### Cowboys and Injuns: a point by point rebuttal of comments made on my Horse Hill-1 analysis by Injuneer

Posted on [7th October 2017](#) by [Professor David Smythe](#)

#### Summary

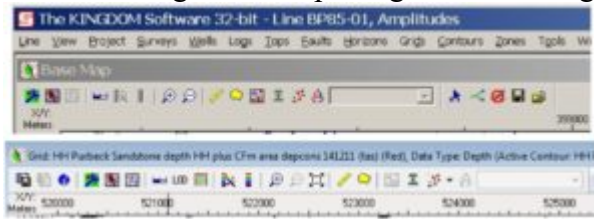
*I would point out that the throws associated with the fault (as marked by yourself on page 6 of your presentation) are actually quite small – certainly in the vicinity of the apparent change in direction of fault throw, such small throws are very difficult to definitively image on 2D seismic of this vintage – there may not even be anything there at all.*

You are inadvertently confirming (not questioning, as you think) two of my main points:

(a) The vertical throw of the UKOG version of the Collendean Farm Fault does indeed diminish to zero locally – i.e. it is not there! Of course, you might argue that it is still present as a strike-slip fault, with no vertical component of throw, but since we are in a no-data zone between seismic lines along the fault trace of some 1500 m, you can hardly argue that, based on no evidence.

(b) The whole prospect was based on inadequate seismic coverage. The coverage that exists comprises three-decade old 2D seismic, some of it reprocessed more recently. The PEDL should not have been granted by DECC/OGA without at least requiring 30-50 km of new 2D seismic to be shot, as a condition.

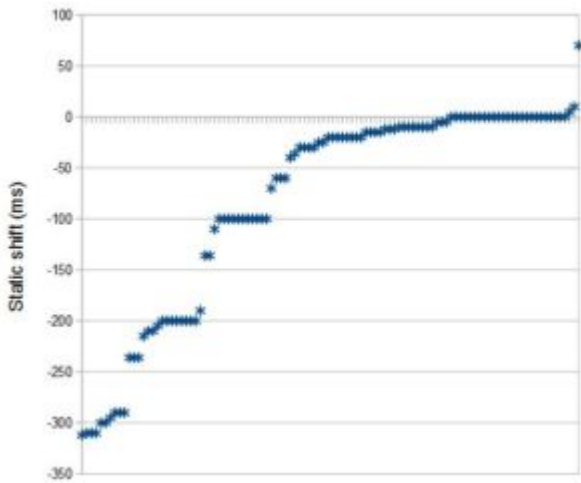
*The Esso line is not used by UKOG – I suspect because they QA/QC'd the data and were not confident in its validity. They certainly did not 'forget it' as you claim. However, if you are confident, why not use it instead of line C80-130 try try and cross-correlate? Although it is a little further from the CF-1 Well than line C80-130, the intersection between it and line BP-85-74 is 1km closer to HH-1 and therefore much more valid.*

I too would preferentially omit the old Esso line from the interpretation, unless a particular problem arose, as it has here, and nothing else was available. But once again you misunderstand the problem. The satisfactory nature of my correlation is that you can tie the two wells by going SW from CF-1 on C80-130, then east on BP-85-74 (my slide 13) by proceeding around the end of the Horse Hill Fault, last identified at H on slide 15. So there are no faults to have to correlate across on that path.

Using your suggestion, we would first have to jump-tie from the well, offset by 285 m from the line (slide 12), then go south on old data, then try to correlate across the CFF at H, which would be very doubtful (slide 14) then tie from SP 1666.5 to the BP line at CDP 125 (see slide 13 where the intersection is marked) and hence to HH-1. This path is much more uncertain than the one I chose to use.

**Figure 1.** A schematic of a fault zone showing the relatively impermeable fault core surrounded by the highly fractured damage zone. In a fractured, low matrix permeability reservoir, fluid from the fractures in the surrounding rock must drain into the highly permeable damage zones.

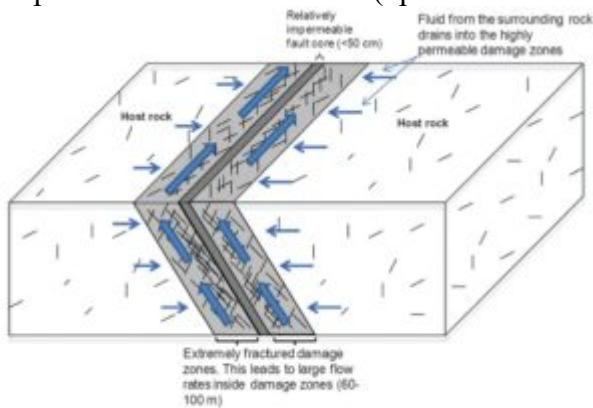
*(29) In the third paragraph on page 16, you state that the flow from the Kimmeridge is due to drilling HH-1 close to the HH Fault; it is the fault that has enhanced the fracture permeability (technically you should state ‘the number of fractures and their size’) and it is just a local effect.*

*This is nonsense. In my experience, any rubble zone that may exist around a fault is very small (just a few m in diameter) and HH-1 is not close enough to see this effect.*

*Indeed, if a rubble zone of the magnitude you imply existed around the HH Fault, then any oil in the structure would have migrated out long ago – especially along such a near vertical fault.*

*In any case, there does not need to be a fault close by for a natural fracture network to exist in a formation.*

Wells frequently fail to identify faults. Balcombe-1 is a good example, which I use as a proxy for Cuadrilla's Balcombe-2. Cuadrilla failed to notice that the BGS geology map indicates a mapped fault, which I predicted would be intersected in the vertical section of the wells. My subsequent analysis of the gamma ray and sonic logs, comparing them with unfaulted Southwater-1, duly identified the fault at 620 m depth, albeit with a throw of only 10 m, and not the 30-40 m I predicted.

You are unfamiliar with the wider research on fault structure. Damage zones on each side of a relatively impermeable fault core zone (up to 50 cm width) can be up to 100 m wide, as shown here.
